Volvo Penta of the Americas
1300 Volvo Penta Drive
Chesapeake, Virginia 23320-9810
USA

Group	Number	Version
22-0	20	01

Dipstick

Models
DPX500, DPX600

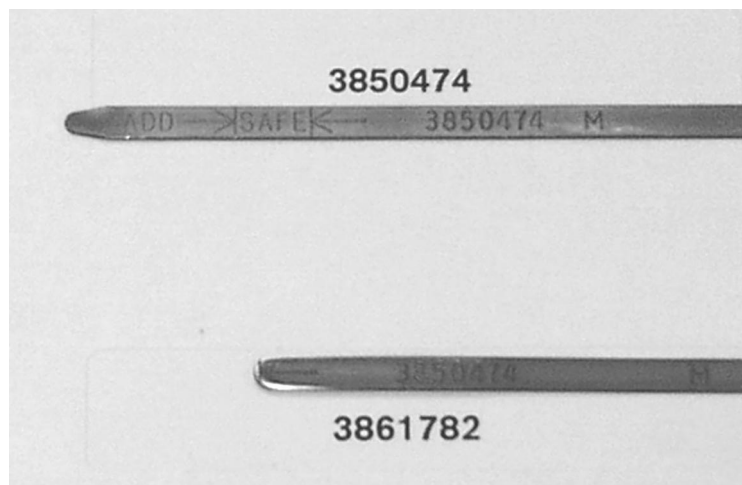
A small number of these engines were produced with factory altered engine oil dipsticks. These dipsticks can be identified using the illustration below. The same part number, 3850474 is stamped on both parts. If you need to replace one of these altered dipsticks order part number 3861782. The "ADD" and "SAFE" marks have been moved to the back of the altered dipstick (3861782).

NOTE: It is always important to insure that the engine crankcase is filled with the correct quantity of oil. The crankcase capacity of these engines is 7.5 liters or 8 quarts (8.5 liters or 9 quarts with filter change). If there is doubt concerning the accuracy of the dipstick, completely empty the crankcase and refill with the correct quantity of oil. If the engine has an un-altered dipstick, 3850474 and the dipstick reads as significantly too full after the refill, replace the dipstick with the 3861782 part. If the engine has an altered dipstick, 3861782 and the dipstick reads as significantly under-filled after the refill, replace the dipstick with the 3850474 part.
